Planning Application Ref: AW/39/14/T

Location : 81a The Fairway, Aldwick

Description of works: Fell 1 No. Conifer – T1 on plan submitted
Lop broken branch on Birch - T4 on plan submitted

Figure 2 Positions of final cuts

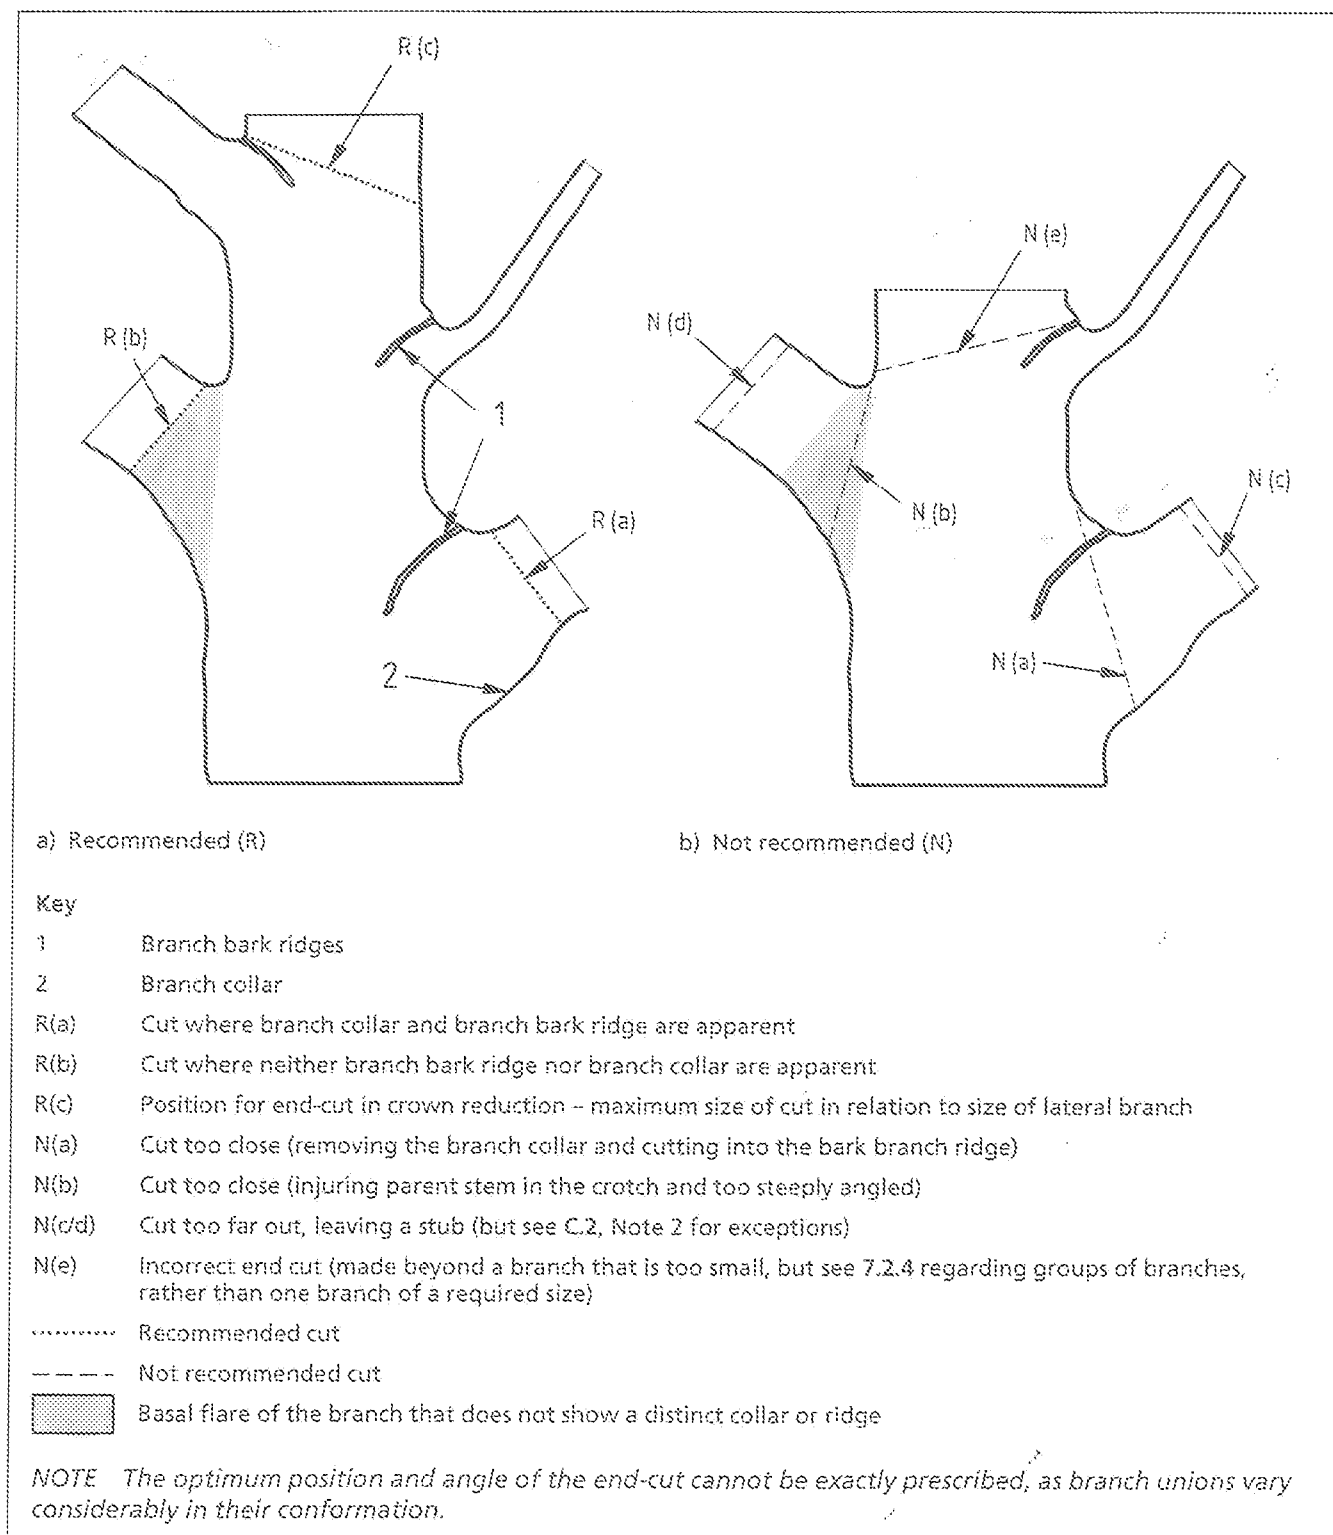
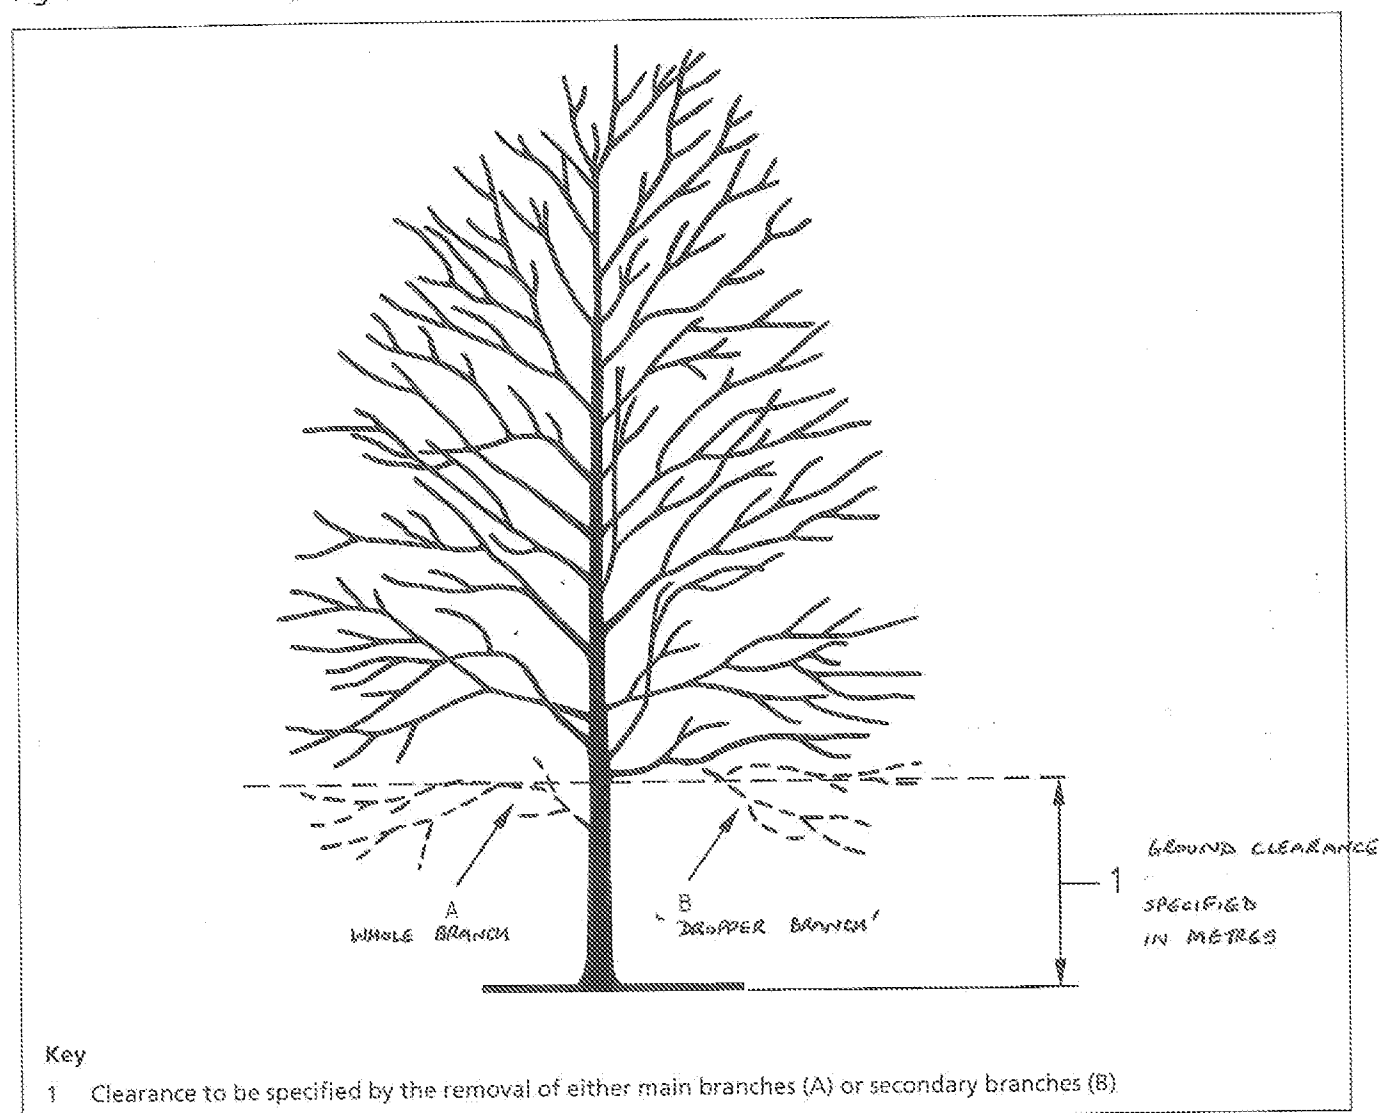
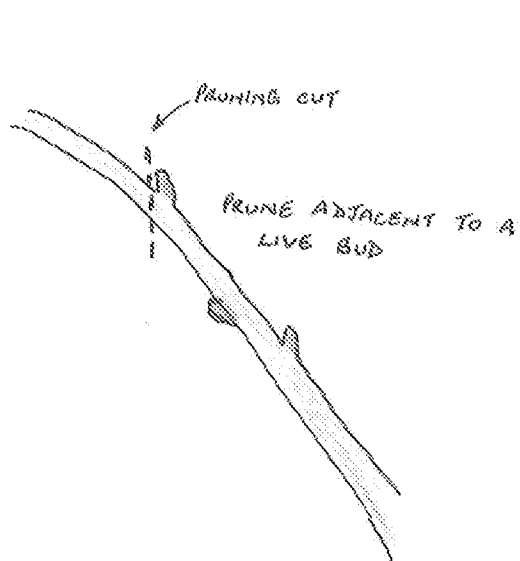
- Remove all storm damaged; split broken and retained branches to tidy and make safe
- Where whole branches are to be removed final cuts close to the trunk or branch union are to be made as shown in Figure 2 of BS3998:2010 and all shortened branches are to be cut at the correct angle (see also BS3998:2010) and adjacent to a live bud or lateral.

Reasons : In the interests of the trees continued health and vitality and to accord with current industry guidelines and sound arboricultural practice. I also recommend that a copy of the Figure 2 diagram and pruning advice sheet are sent out with the consent letter.
